Re: Golden Peak Improvements Project DEIS

Subject: Engineering Consultation  
Golden Peak Improvements Project  
Vail Ski Area  
Vail, Colorado  
Project No. GS06142.000-145

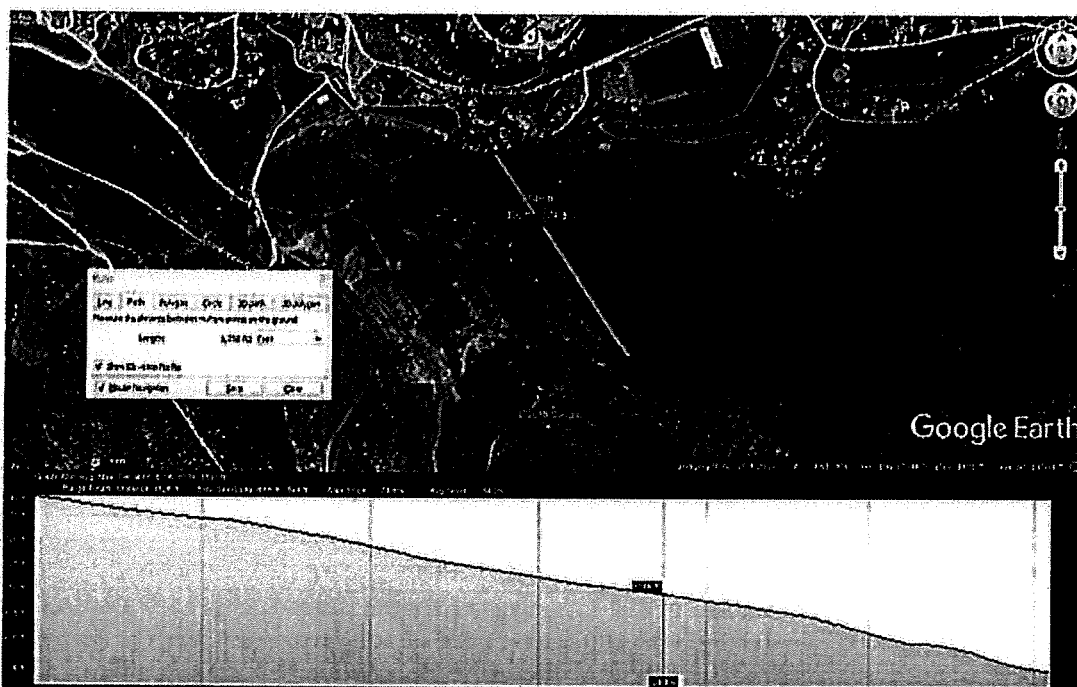
We believe drainage basin GP-2C shown on the plans we reviewed in the LRE report may extend into basin GC-1B and north towards the Town of Vail. Analysis by LRE determined that within drainage basin GP-2C (mogul course) the area covered by snowmaking will change from 7.7 acres to 13.0 acres (59% increase) and water usage will change from 16.5 acre-feet to 24.5 acre-feet (67%). Tree cleared area will change from 18.0 acres to 30.6 acres (59%). LRE in their "Hydrologic Conditions" section of their report state that the above changes will result in increases in total runoff and peak runoff flow.

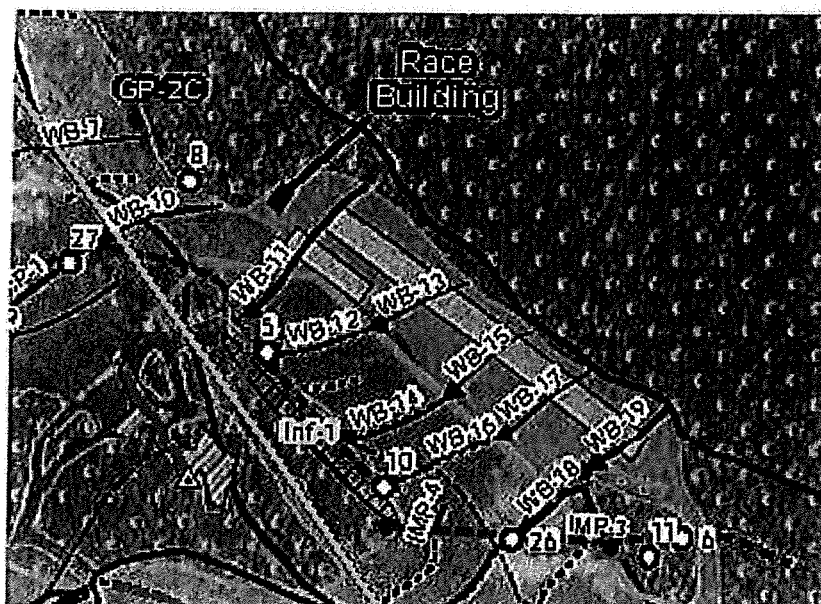
This slope profile, generated with Google Earth, indicates that surface and subsurface water at the base of the mogul course is likely to travel to the slopes directly above the Northwoods property. Tree clearing, reshaped surface grades, and additional manmade snow required for the course is likely to increase the amount of surface runoff and subsurface water to the slope directly above Northwoods. This could increase driving forces for slope failures and sediment loads resulting in mudfloods and mudflows.

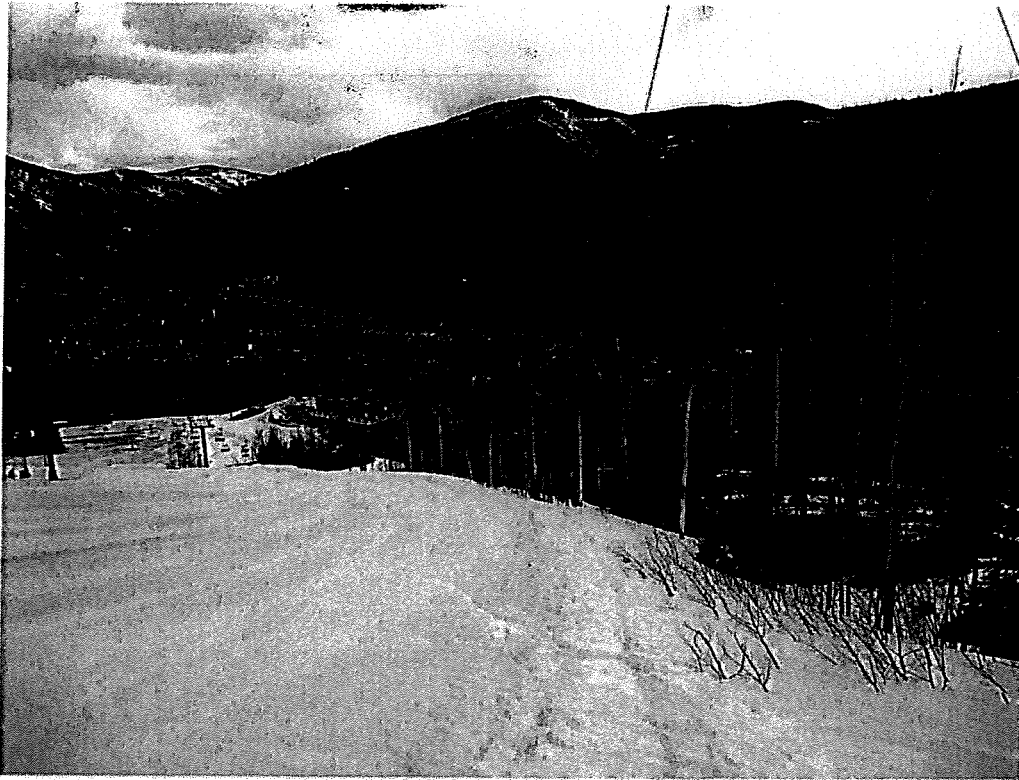
Incised Drainage Channel Above Northwoods

Proposed Mogul Course Location
